DESIGN [Signature]	DRAWN BY RF	DART AEROSPACE LTD HAWKESBURY, ONTARIO, CANADA	
CHECKED [Signature]	APPROVED [Signature]	DRAWING NO. DEO 9176	REV. A SHEET 1 OF 1
DATE 99.12.10		TITLE ADDITIONAL WEARPLATES	SCALE NTS
A	99.12.10	NEW ISSUE

DART ENGINEERING ORDER

TO AMEND DRAWING D2577 REV. D

FIGURE 1

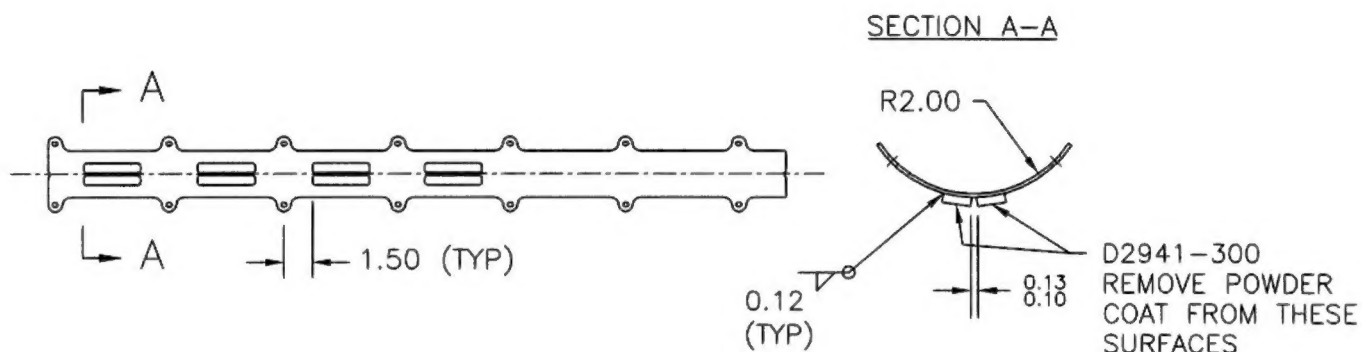
SAME AS D2577-1 EXCEPT THAT 7560 HARDCOAT WELDS ARE REPLACED BY D2941-300 SHWAYDER™ WEARPADS AS SHOWN IN FIGURE 1, JOGGLE IS NOT SHOWN FOR CLARITY.

SAME AS D2577-3 EXCEPT THAT 7560 HARDCOAT WELDS ARE REPLACED BY D2941-300 SHWAYDER™ WEARPADS AS SHOWN IN FIGURE 1.
